PIC24FJ256DA210 FAMILY

PIC24FJ256DA210 Family Silicon Errata and Data Sheet Clarification

The PIC24FJ256DA210 family devices that you have received conform functionally to the current Device Data Sheet (DS39969B), except for the anomalies described in this document.

Data Sheet Clarifications

FIGURE 2-3 FREQUENCY vs. ESR PERFORMANCE FOR SUGGESTED VCAP

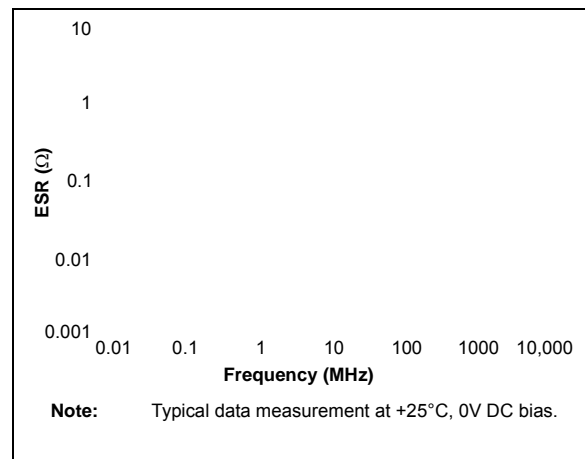
Section 2.4 “Voltage Regulator Pins (ENVREG/DISVREG and VCAP/VDDCORE)” has been replaced with a new and more detailed section. The entire text follows:

When the regulator is enabled, a low-ESR ($< 5\Omega$) capacitor is required on the VCAP pin to stabilize the voltage regulator output voltage. The VCAP pin must not be connected to VDD and must use a capacitor of 10 μF connected to ground. The type can be ceramic or tantalum. Suitable examples of capacitors are shown in Table 2-1. Capacitors with equivalent specifications can be used.

Designers may use Figure 2-3 to evaluate ESR equivalence of candidate devices.

FIGURE 2-4 DC BIAS VOLTAGE vs. CAPACITANCE CHARACTERISTICS

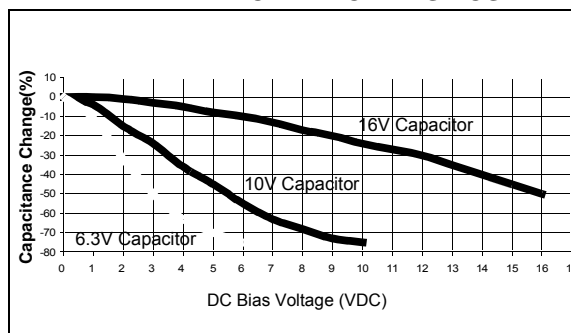
In addition to temperature tolerance, the effective capacitance of large value ceramic capacitors can vary substantially, based on the amount of DC voltage applied to the capacitor. This effect can be very significant, but is often overlooked or is not always documented.

A typical DC bias voltage vs. capacitance graph for 16V, 10V and 6.3V rated capacitors is shown in Figure 2-4.

When selecting a ceramic capacitor to be used with the internal voltage regulator, it is suggested to select a high-voltage rating, so that the operating voltage is a small percentage of the maximum rated capacitor voltage. For example, choose a ceramic capacitor rated at 16V for the 1.8V VCAP voltage. Suggested capacitors are shown in Table 2-1.

FIGURE 30-1: PIC24FJ256DA210 FAMILY VOLTAGE-FREQUENCY GRAPH (INDUSTRIAL)

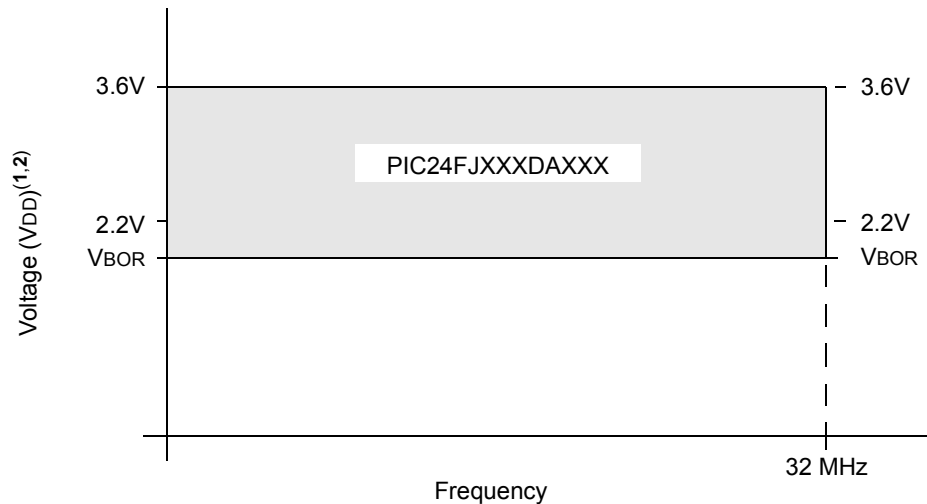
Figure 30-1 (“PIC24FJ256DA210 Family Voltage-Frequency Graph”) is amended by adding an additional footnote. The updated figure is shown below (changes in **bold**; bold in original removed for clarity).

Note 1: VCAP (nominal On-Chip Regulator output voltage) = 1.8V.

2: When the USB module is enabled, VUSB should be provided at 3.0V to 3.6V. When the USB module is not enabled, the wider limits shaded in grey apply. The voltage on the VUSB pin should be maintained at (VDD – 0.3V) or greater. Optionally, the pin may be left in a high-impedance state when the USB module is not in use, but doing so may result in higher IPD currents than specified.
